# Cascade Hydrogeo Study: Questions and Clarification

We noticed a number of anomalies and missing information in the hydrogeo report presented by Mr. Zieff’s team, which require answers and clarification:

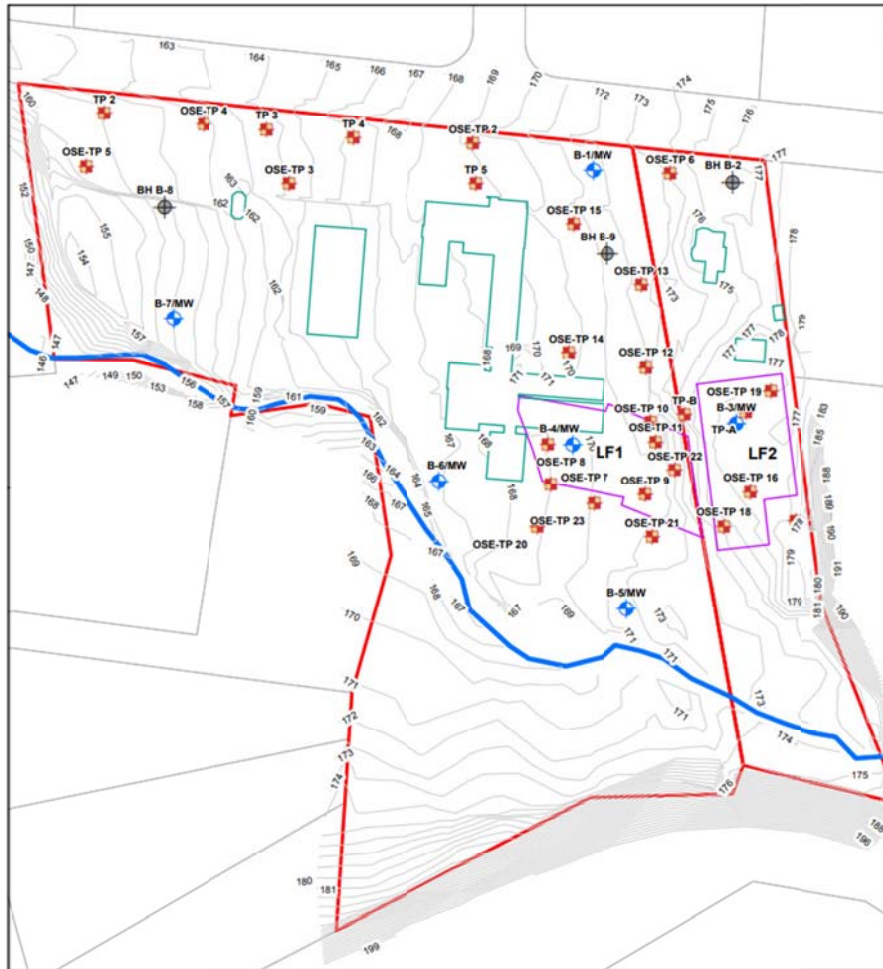
**6. Soil analysis problems:** There are a number of issues with the test reports and data in Appendix C which would affect the hydrogeo model, including missing tests, different test protocols, tests based on an ASTM standard that was retired in 2015 due to accuracy problems, and inconsistent testing that did not follow the protocols.

Figure 4. East-west cross section through MW4. Orange cells are Layer 1; dark blue = Layer 2; cyan = GHB; yellow = DRN; gray = No flow. Line of cross section shown in Figure 5.

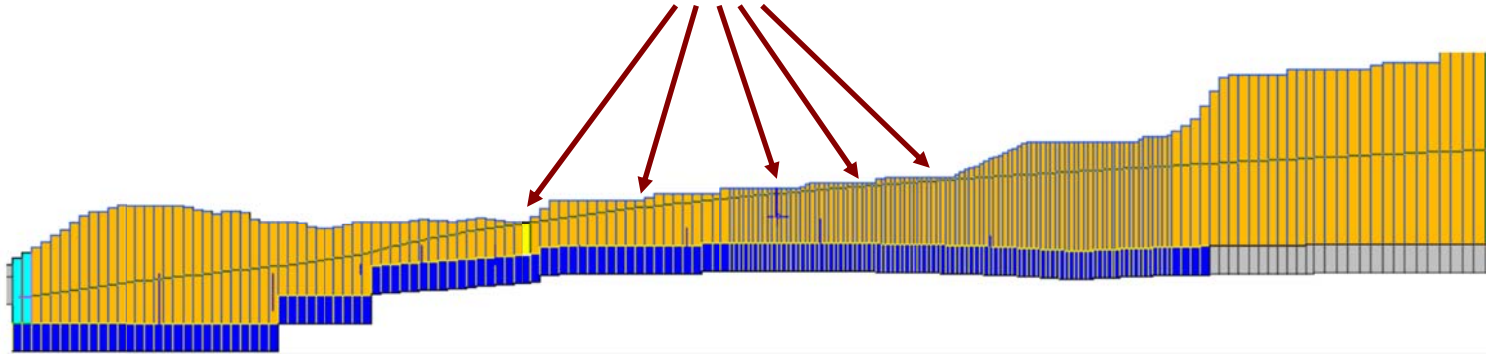
8. **Septic mound / ground water level:** A cross section graph is included at the top of page 5 in Appendix D, as shown below. The line that runs horizontally is not labeled. Is this the level of the septic mound and ground water, which is very close to the surface in the middle of the graph? Assuming this line represents the water table, sensitivity analyses (see comment 22 below) may demonstrate that breakout of wastewater would occur across the surface in these areas and next to Pine Brook - which would carry hazardous biocontamination downstream.

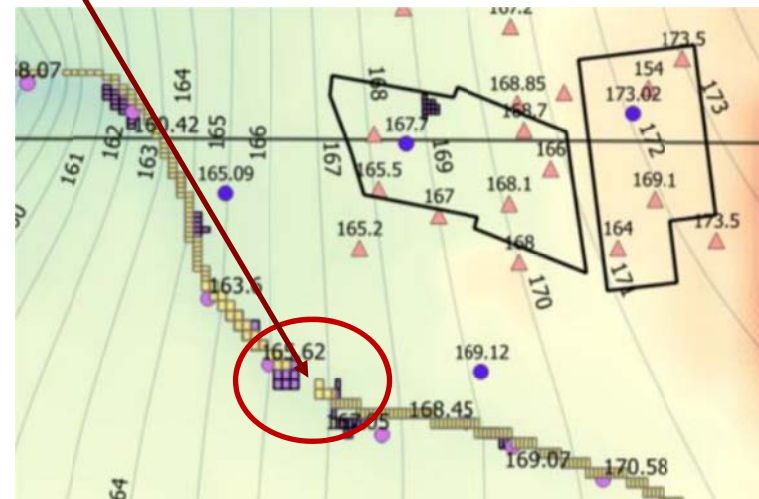
9. **Gap in Pine Brook drain:** There is a gap in the Pine Brook 'drain' which appears in all of the model maps as shown below – next to two break-out areas. Why was a gap included in this key feature? Every indication is that the Brook is continuous and should be modeled as such.

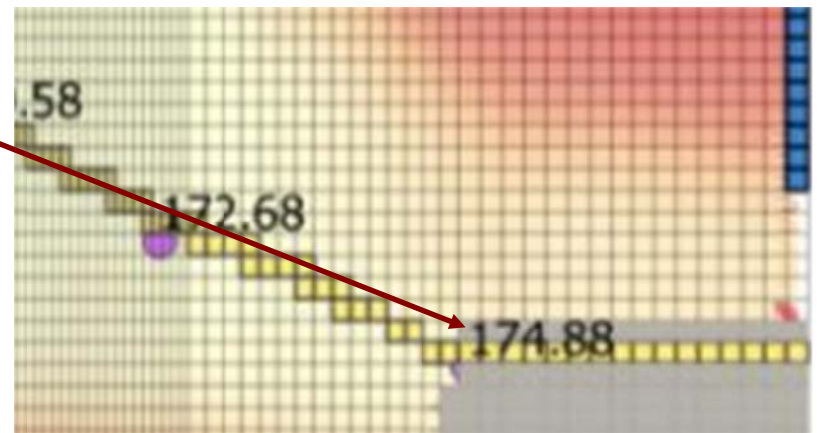
**11. Width and depth of Pine Brook:** The “drain” (DRN) function was used to simulate Pine Brook in the model. Were the following Conductance variables used? If so, how were they set? Conductance is described as having units of  $L^2/T$  and is equal to  $KLW/M$  where

If Conductance variables were not used, please clarify which variables were used to define the Pine Brook drain, and how they were set.
